SERVICE BULLETIN

N° 139-601

ATA 33 – INSPECTION AND REINFORCEMENT OF SEARCHLIGHT SUPPORT

Figure 2

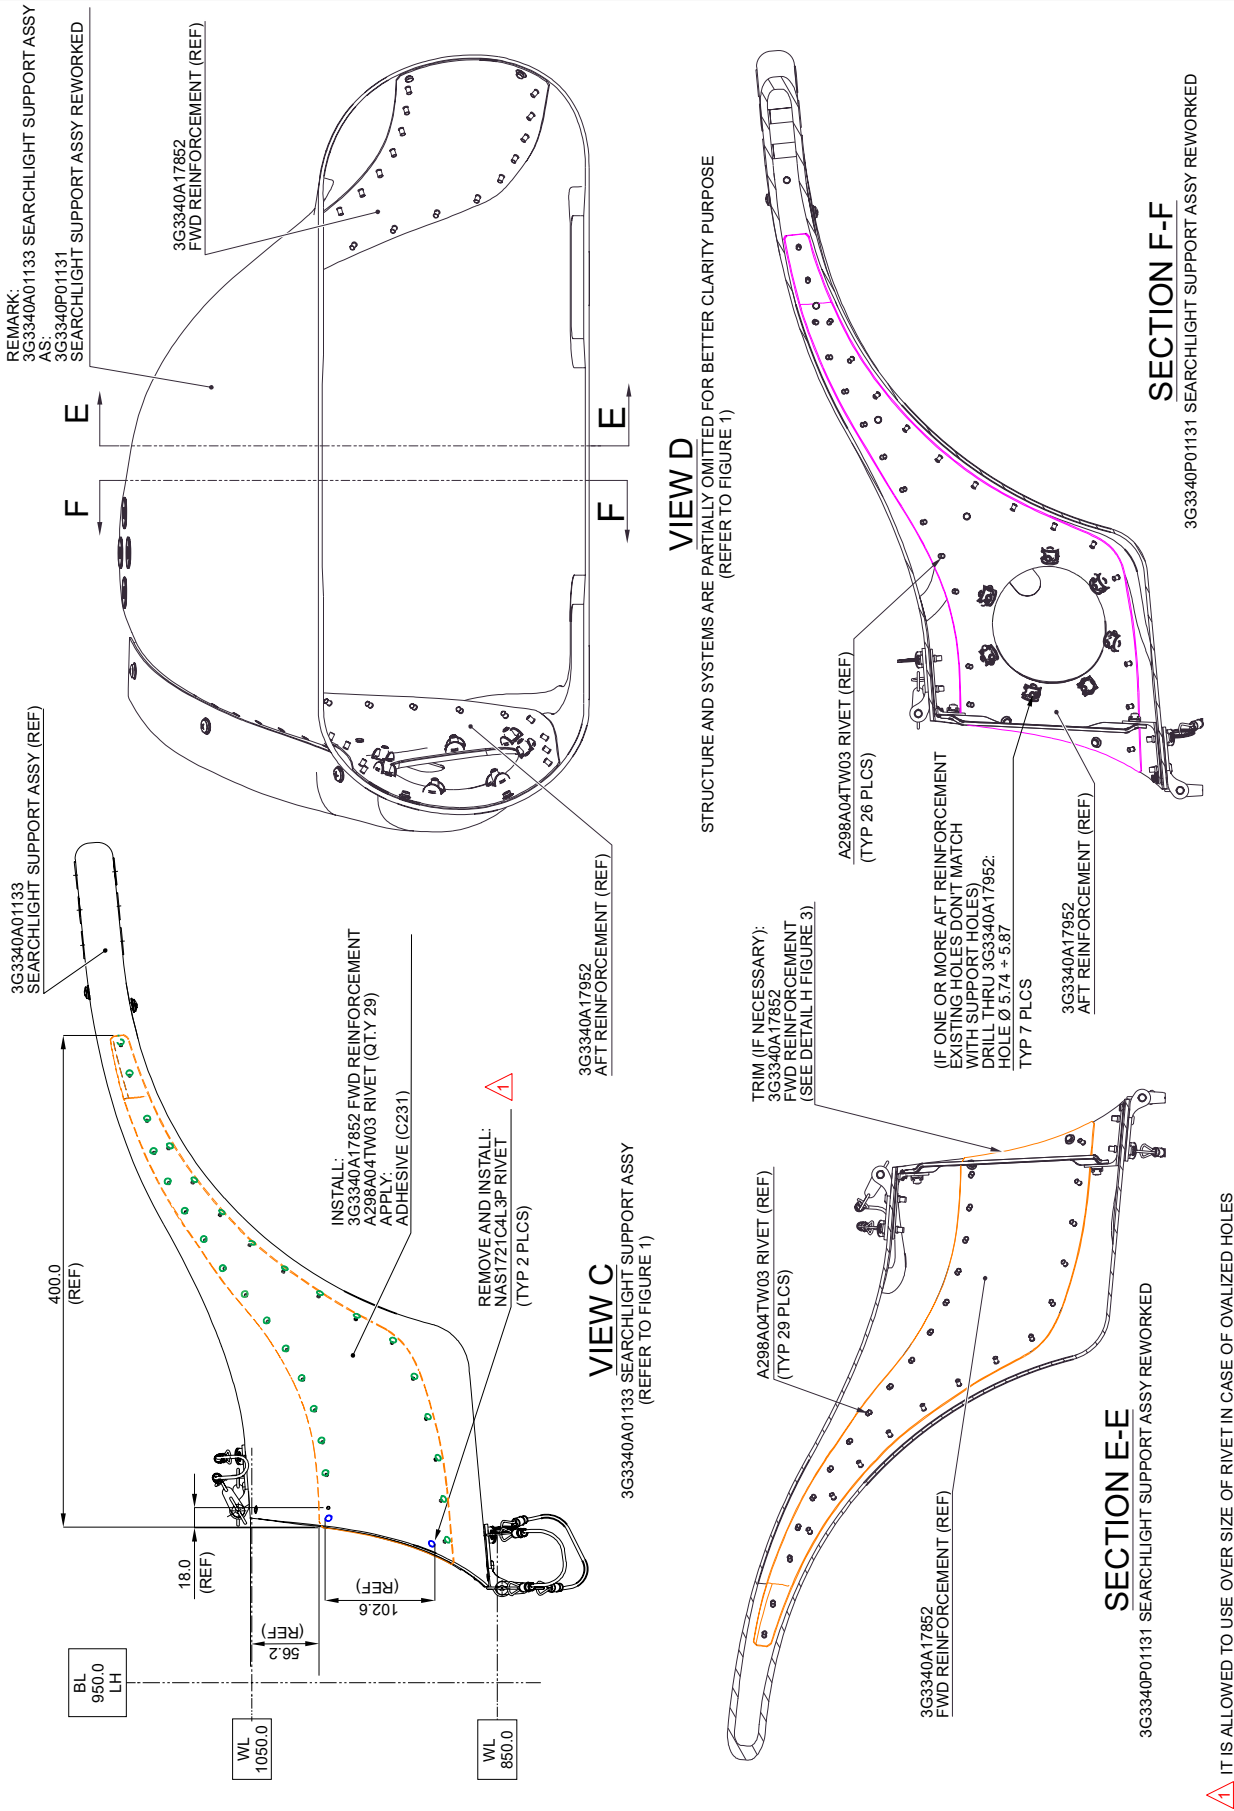
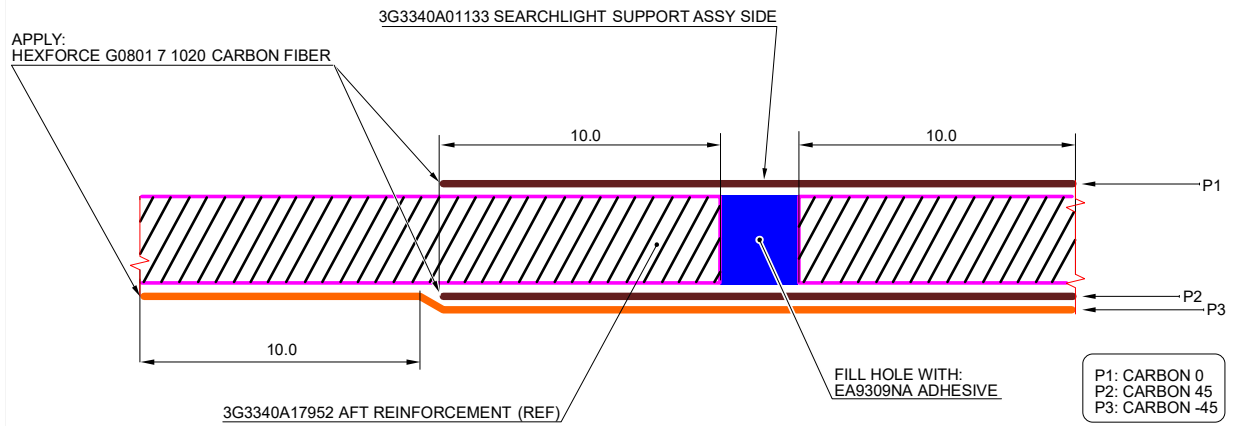
- 4.4 With reference to Figure 1 View B1, remove and retain for later reuse the support P/N 3G3340A03551 and remove and discard the rivet P/N NAS1720C4L5P, n°3 rivets P/N NAS1720C4L4P and n°2 rivets P/N NAS1721C4L4P from the searchlight support assy.
- 4.5 With reference to Figure 2 Section F-F, temporary locate the AFT reinforcement P/N 3G3340A17952 in its position inside the searchlight support assy.

- 4.7 With reference to figure 2 Section F-F, countermark 26 rivet holes on the searchlight support assy.

- 4.11 With reference to figure 2 Section E-E, countermark 29 rivet holes on the searchlight support assy.
- 4.12 With reference to Figure 2 View C and in accordance with dimension shown, install the FWD reinforcement P/N 3G3340A17852 on the searchlight support assy by means of adhesive (C231).

- 4.13 With reference to Figure 2 View C, fix the FWD reinforcement P/N 3G3340A17852 on the searchlight support assy by means of n°29 rivets P/N A298A04TW03 and n°2 rivets P/N NAS1721C4L3P.

- 4.19 With reference to Figure 2 Detail D, Section E-E and Section F-F, remark the reworked searchlight support assy as P/N 3G3340P01131 by means of an indelible pen.

Figure 3

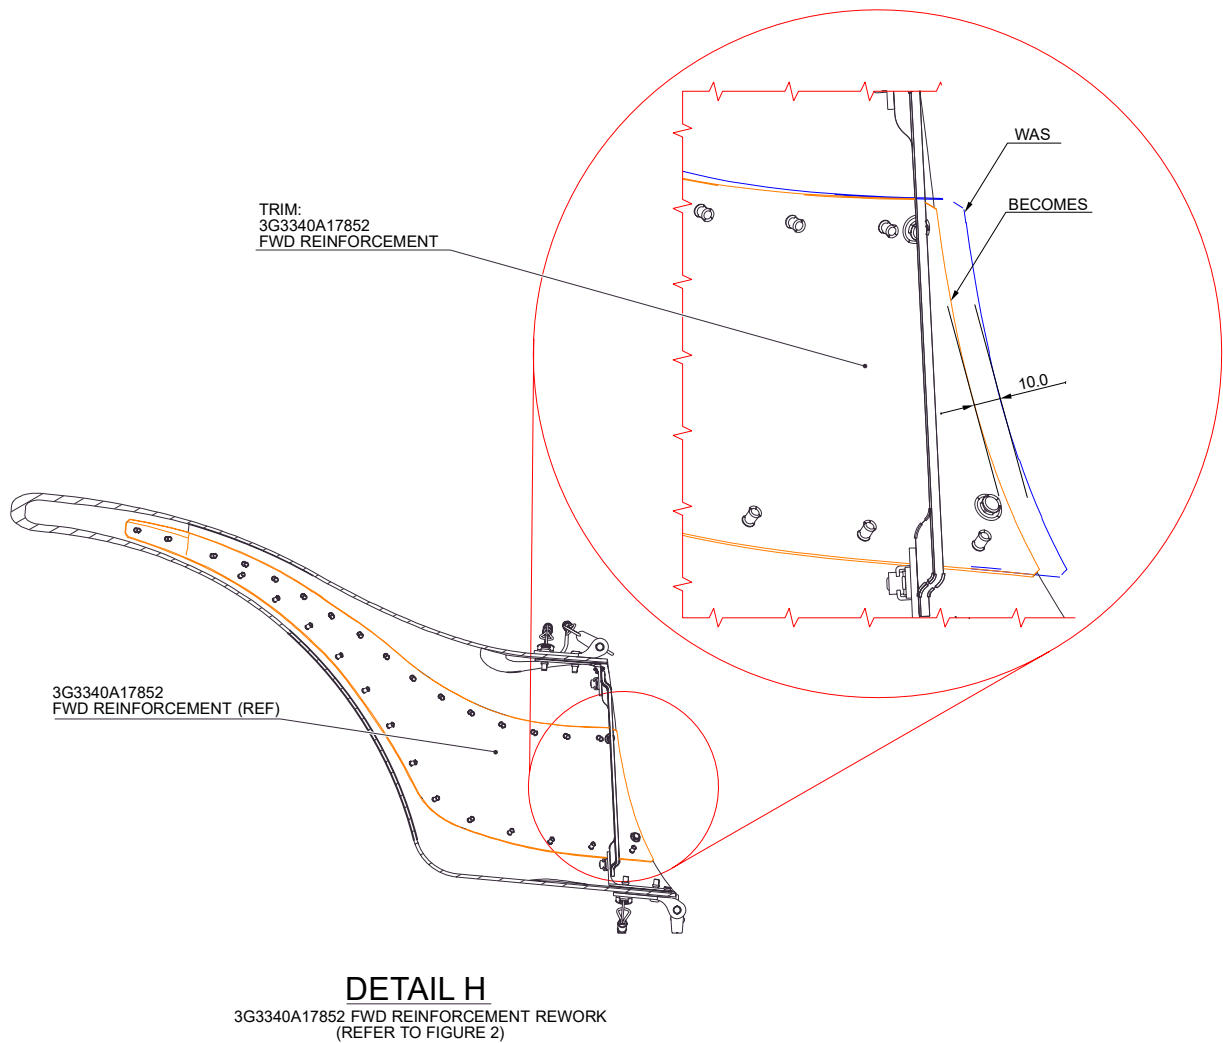
- 4.6.1 With reference to Figure 3 Section G-G, apply a layer (P1) of Carbon fiber dry fabric HexForce G0801 7 1020 and let it cure.
- 4.6.2 With reference to Figure 3 Section G-G, fill 7 screw holes with EA9309NA.
- 4.6.3 With reference to Figure 3 Section G-G, apply a layer (P2 and P3) of Carbon fiber dry fabric HexForce G0801 7 1020 and let them cure.
- 4.6.4 In accordance with CSRP-A-51-21-02-00A-028A-D, protect repaired area with primer.
- 4.6.5 With reference to Figure 2 Section F-F, countermark and drill n°7 screw holes $\varnothing 5.74 \div 5.86$ thru the aft reinforcement.

- 4.10 With reference to Figure 3 Detail X, temporary locate the FWD reinforcement P/N 3G3340A17852 and trim it as indicated.

SCHEMATIC SECTION G-G

(IF ONE OR MORE AFT REINFORCEMENT EXISTING HOLES DON'T MATCH WITH SUPPORT HOLES)
(TYP 7 PLCS)
(REFER TO FIGURE 1)
